***(MA) Architectural Review Application for Garage, Uncovered Decks, Pergola, Signs, Facade changes, Shed - Minor changes (no variance) Staff Review -**

69 S CASSINGHAM RD
 Bexley, OH 43209

MA-20-49

A new two car garage located in the north west corner of the property.

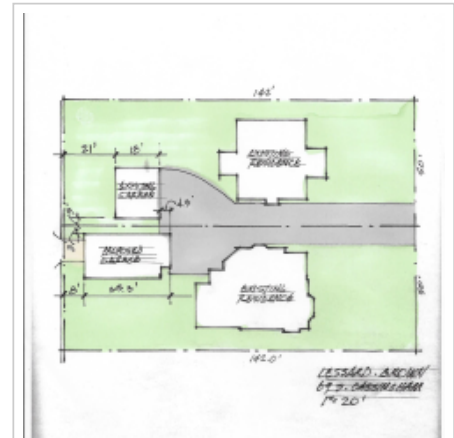
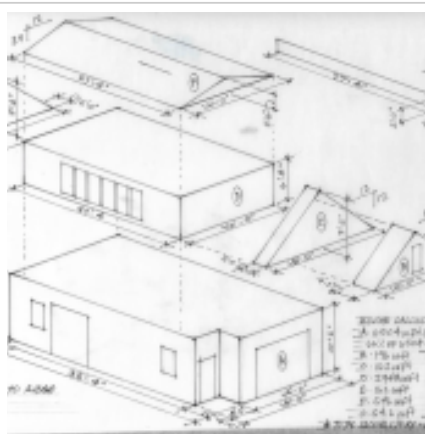
How is this not a variance for a 2-story garage?

Pete, I think the design is nice based on the detail, I'm still struggling with the mass. it is clearly a 2-story garage that is over 35' long and not typical at all. I know you like to build out structure without the need for a variance. This is an exception to the rule and not the intent of why the height in the code was raised. Also the volume of "gross" space should be used in the calculations and not just the finished area. It appears the peak over the front garage door is excluded. I am basing my decision on those facts and the fact that I'm questioning myself if this is an appropriate structure in every back yard in Bexley, That would be my mistake if it is not. I will defer to the Board. I can forward your construction documents during the review process, which puts you less than 2 weeks behind. I'm happy to get a legal opinion, but at this rate Karen and I have put more time into this review to consider it minor.

i have concern on the volume and size

This seems like it should go to the Board for aesthetic review - the volume seems boxy....

Pete.... Kathy and I both agree that this pushes the edge and it needs to go to the Board for ARB - we are both concerned about the overall massing - better to be safe than sorry.

I see that you are working with the current code; however the resulting design does not align with the intent. The system allows for a second opinion on the structure from the Architectural Review Board. I will defer to them and place it on the upcoming agenda. A hard copy of the plan will allow me to verify the calculations. You are welcome to provide additional options.
